From: ben whitby <benwhitby15@yahoo.co.uk>
Sent: 16 July 2012 22:22
To: Hannah Barker
Cc: jon tanner
Subject: Re: AWDM/0674/12 126 Old Fort Road Shoreham
Attachments: 02 Proposed Planning Revision A.pdf

Project:
Proposed Conversion of Chalet Bungalow to Two Storey House
At:
126 Old Fort Road
Shoreham Beach
Shoreham By Sea
West Sussex
BN43 5HL

Drawing title:
Plans & Elevations As Proposed

Drg. No.	Rev'n
02	A

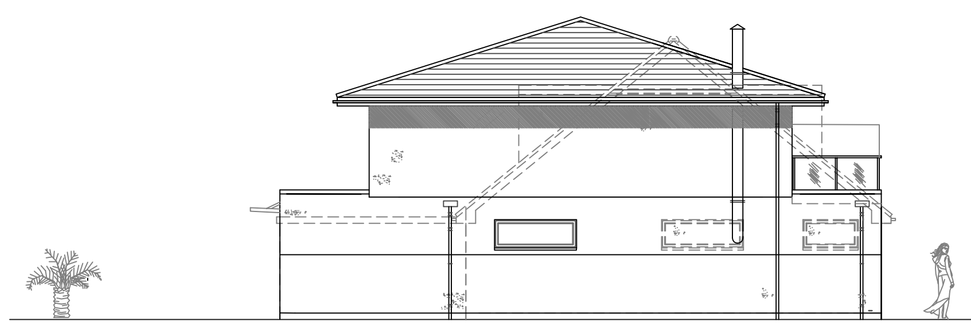
Just writing up the report for 126 Old Fort Road and accept that there will be no overlooking as a result of the proposed balcony to no. 124 however could I have a revised plan to show a high level privacy screen to the eastern end of the balcony adjacent to no. 128 as the balcony will cause loss of privacy to the garden and adjacent conservatory.

Please find attached rev a which includes a high level obscured glazed screen to east end of rear balcony. We now look forward to planning approval in due course.
